# Access Compliance Report

## Public Rights-of-Way

### (Curb Ramps)

Intersection ID: 13600	Main Street: 3RD-4TH_CONNECTOR_ST	Cross Street: E_4TH_ST	Location: W
ADA ID: A9103A7ED37B	Ramp Type: Perp	Initial Pass/Fail: Fail	Overall Compliance: No
			Severity Score: 22.5
Codes/Mitigation Info/Possible Solution		Field Measurements/Component Compliance

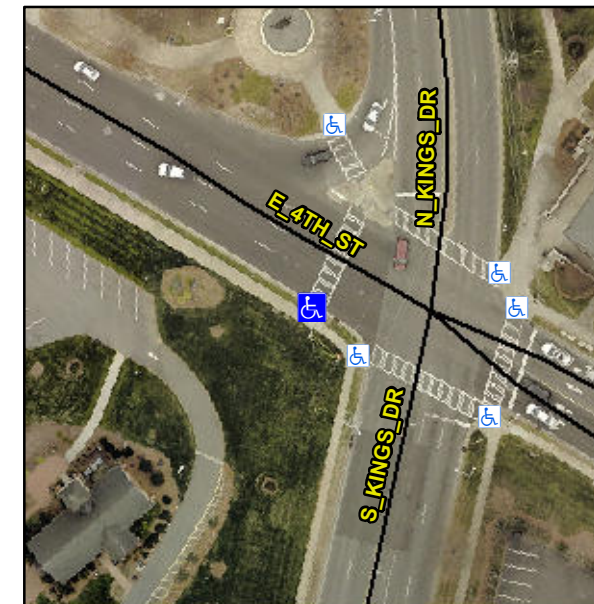
**Not Found, R304.5.1, R304.2.2, R304.5.3**

Compliance	Description	Data	Compliance	Description	Data
N/A	Ramp Length (in)	43.0	No	Ramp Slope (%)	11.3
No	Ramp Width (in)	47.0	No	Ramp XSlope (%)	3.7
N/A	Flare Type LT	N/A	N/A	Flare Type RT	N/A
N/A	Flare Slope LT (%)	N/A	N/A	Flare Slope RT (%)	N/A
N/A	Flare Traversable LT?	N/A	N/A	Flare Traversable RT?	N/A
N/A	Landing Length (in)	N/A	N/A	DWS Provided?	N/A
N/A	Landing Width (in)	N/A	N/A	DWS Contrast?	N/A
N/A	Landing Slope (%)	N/A	N/A	DWS Length (in)	N/A
N/A	Landing X Slope (%)	N/A	N/A	DWS Full Width?	N/A
N/A	Landing Curb? (Y/N)	N/A	N/A	DWS Offset (in)	N/A
N/A	Shared Landing?	N/A			
N/A	Gutter Ponding?	N/A	N/A	Gutter Slope (%)	N/A
N/A	Gutter Lip Ht (in)	2.0	N/A	Gutter X Slope (%)	N/A
N/A	Painted X Walk1?	Yes	N/A	Painted X Walk2?	N/A
	X Walk 1 Direction	To NE		X Walk 2 Direction	N/A
N/A	X Walk 1 Width (in)	107.0	N/A	X Walk 2 Width (in)	N/A
	X Walk 1 Slope (%)	3.2		X Walk 2 Slope (%)	N/A
	X Walk 1 X Slope (%)	3.5		X Walk 2 X Slope (%)	N/A

**Remove & Replace Entire Ramp.**
